RE: Self-Implementing PCB Remediation
USEPA ID Number NYD 003 907 045
Former Empire Electric Company
5200 1st Avenue
Brooklyn, NY 11232

Empire Electric 2017 Photo Summary

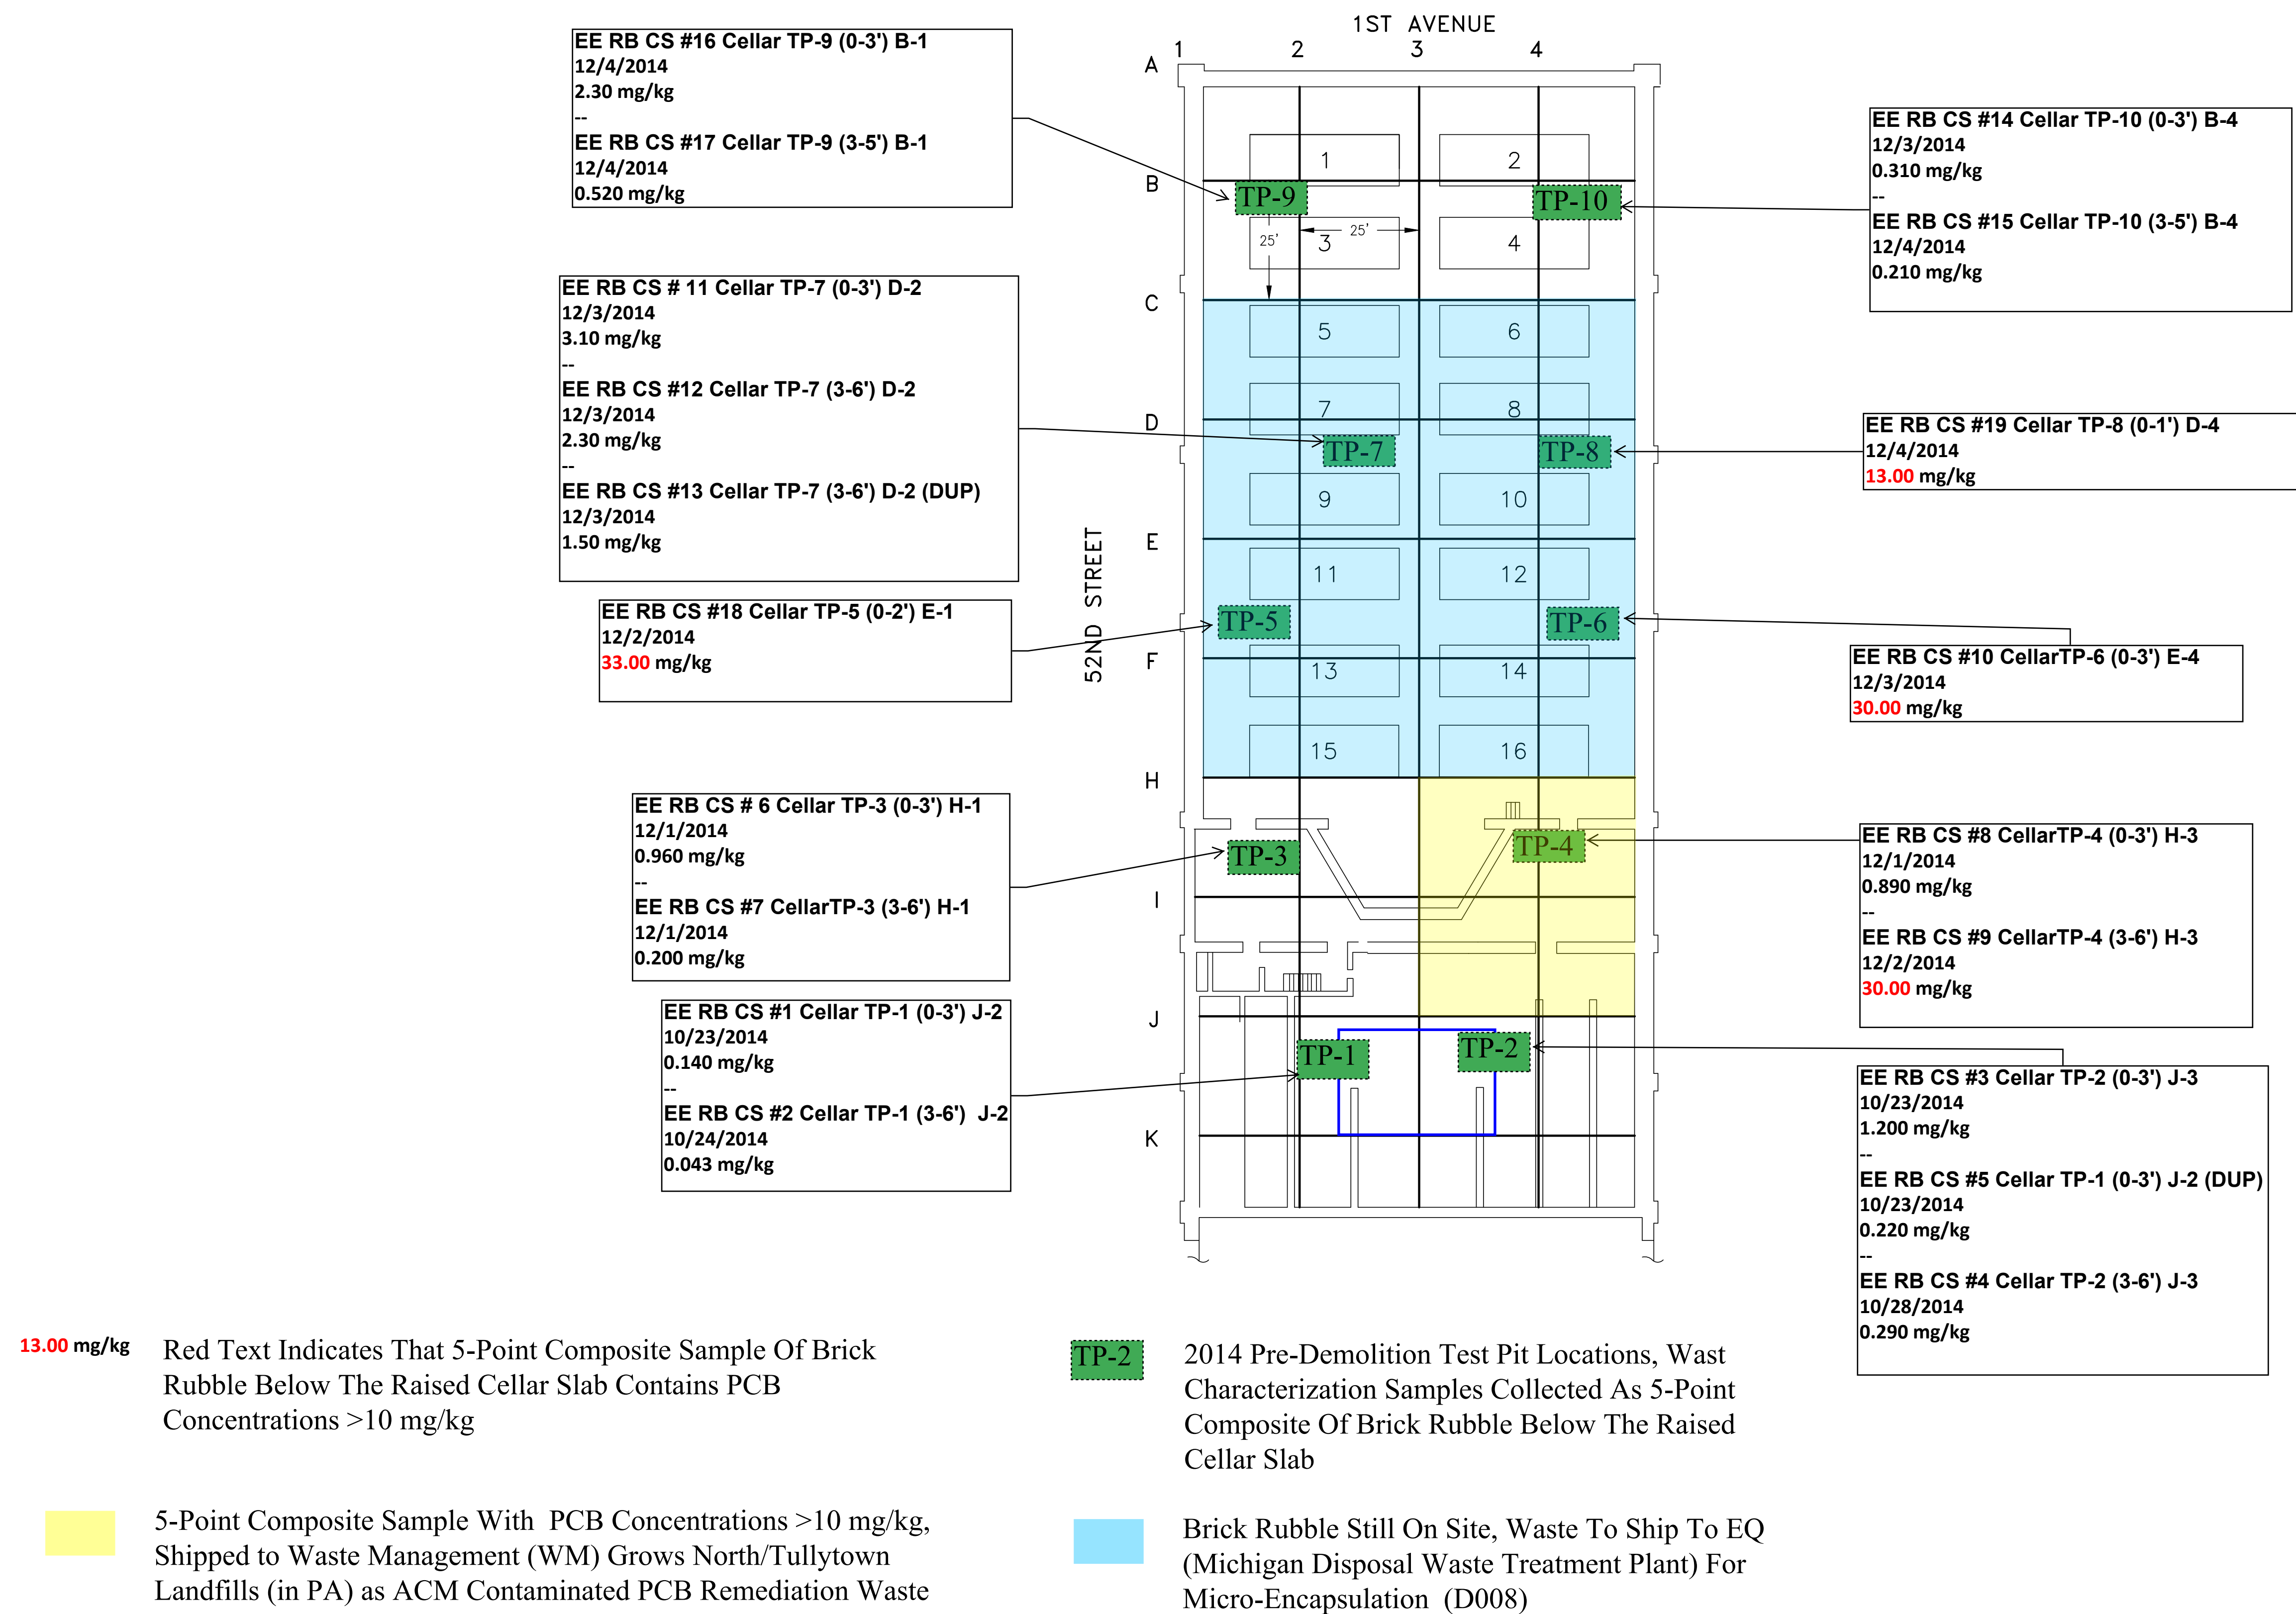
cleanup objective of 1 mg/kg. The proposed sampling to verify completion of the PCB cleanup will be performed by sampling on a 20 ft. grid as shown on Figure 2. Samples grids that exceed the cleanup objective of 1 mg/kg will have the entire grid area scarified using either hand held jack hammers or a hydraulic hammer mounted on an excavator then be resampled. In the event that scarification is not effective at achieving the cleanup objective then EPA will be contacted to determine an appropriate course of action.

FIGURE 3

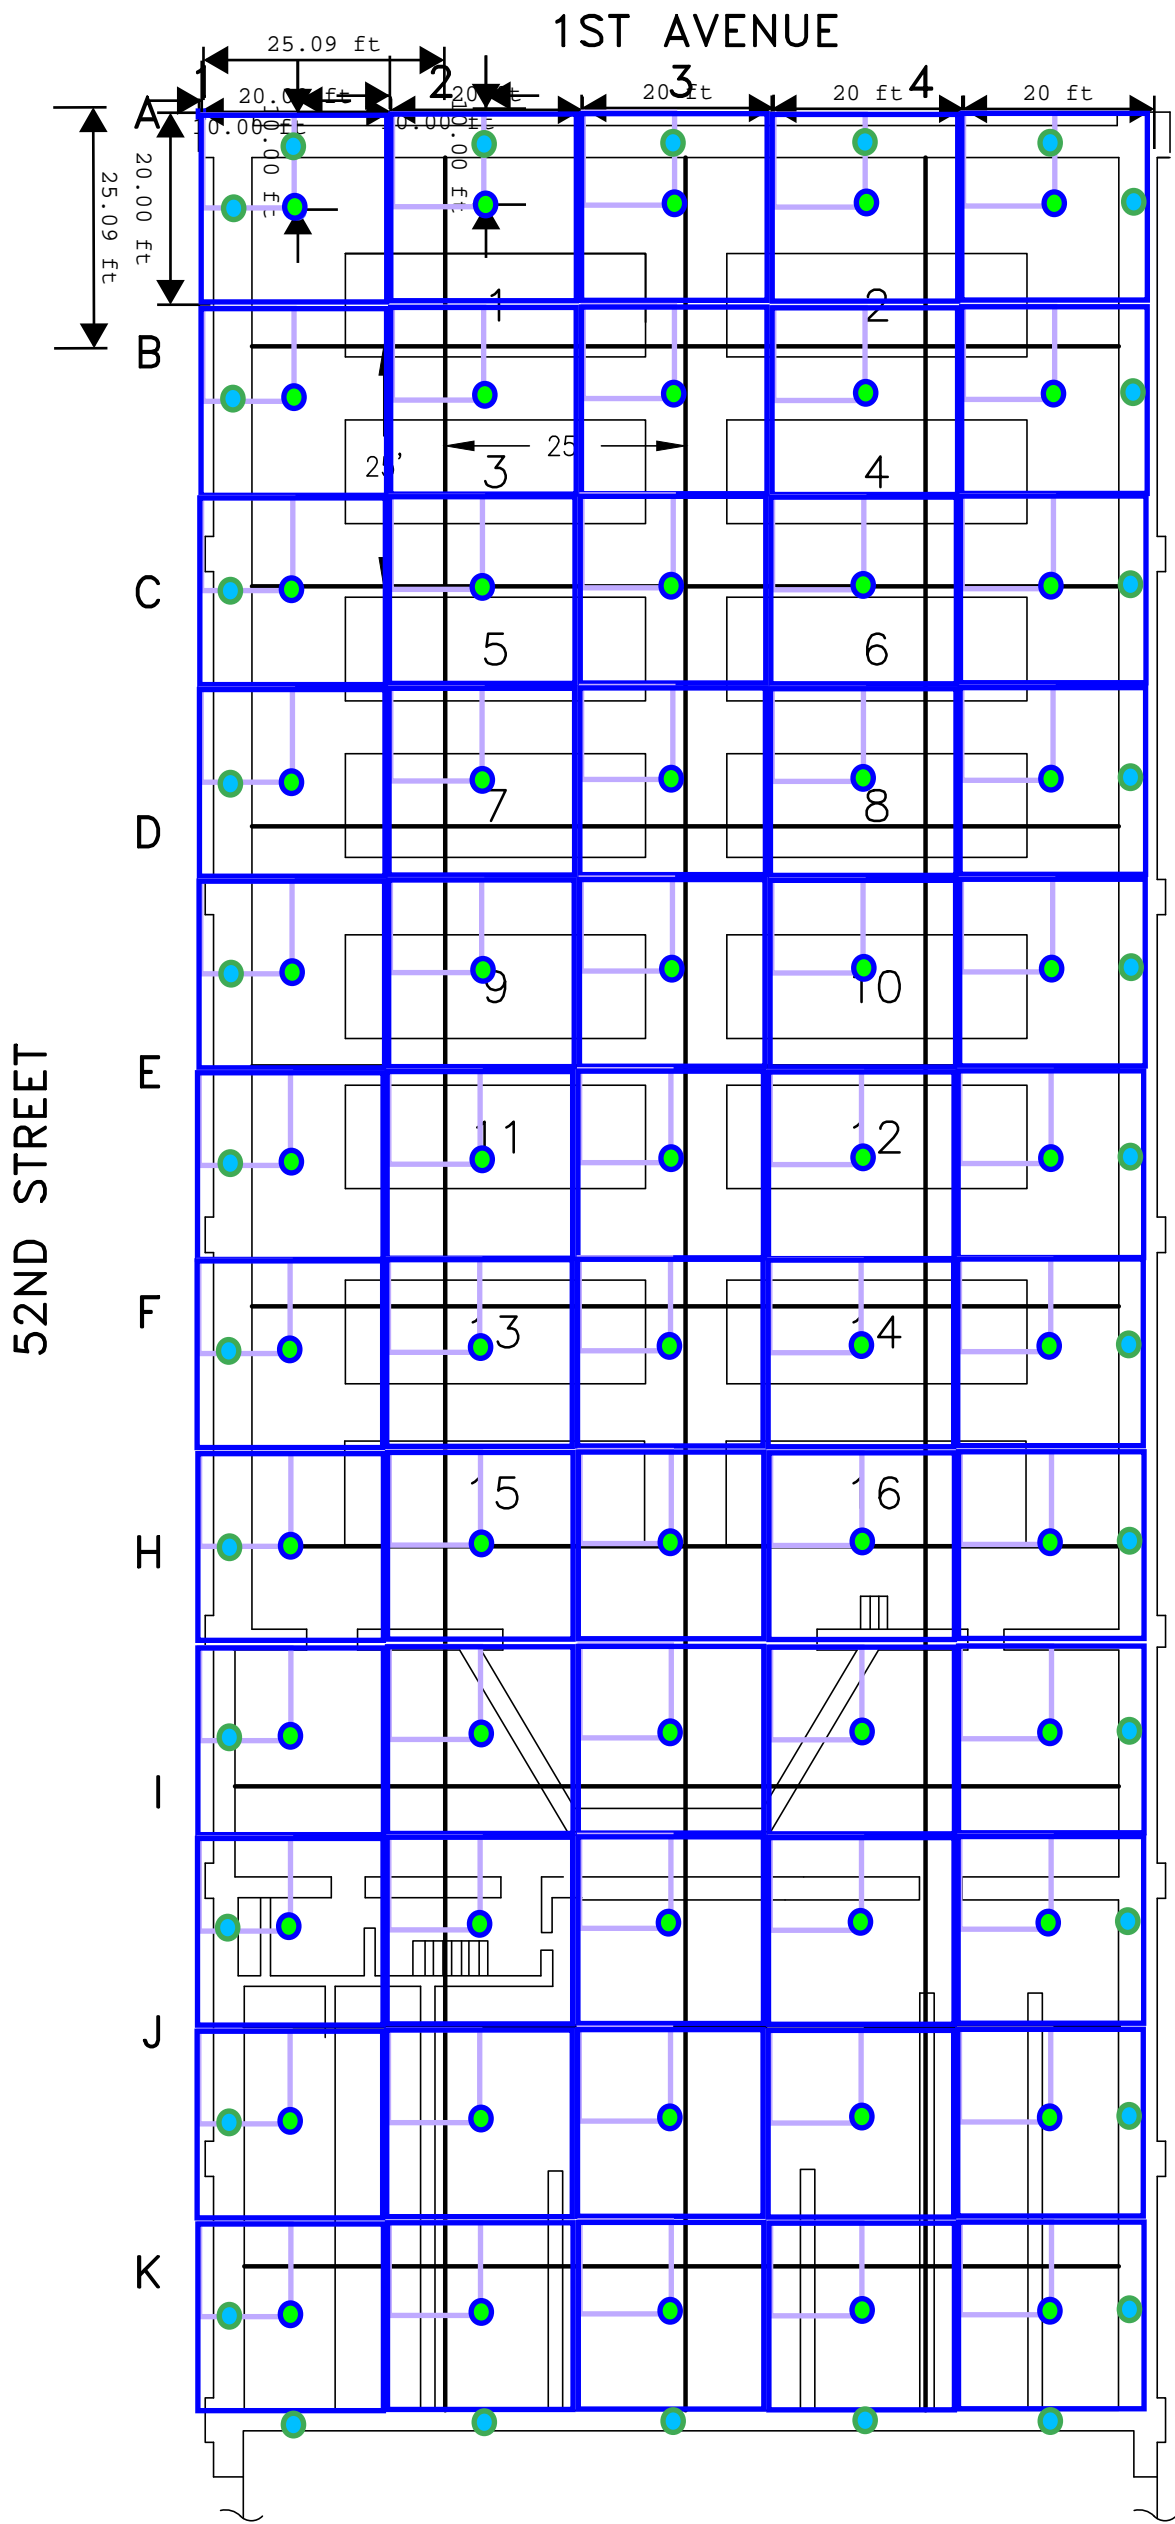
Currently, the remediation contractor (PAL) has completed demolition of the superstructure and is working on remediating the brick rubble under the cellar slab. As seen in the attached photographs (Figure 3), there is a minimum of 2.5 ft. of concrete and granite block foundation components covering the southern portion of the building footprint; these foundation components contain less than 1 mg/kg PCBs, and in the northern portion of the building footprint, there is a 50 ft. x 50 ft. granite smoke stack foundation with PCB concentrations less than 1 mg/kg. The plan is to leave the uncontaminated foundation components in place and backfill above them.

As this is a change from the plan submitted to your office in 2009, EA wanted to notify EPA of the revised plan. Furthermore, due to the irregular surface of the different foundation components, the PVC membrane that was to serve as a demarcation layer/device is no longer necessary, and would be difficult to impossible to install over the irregular surface.
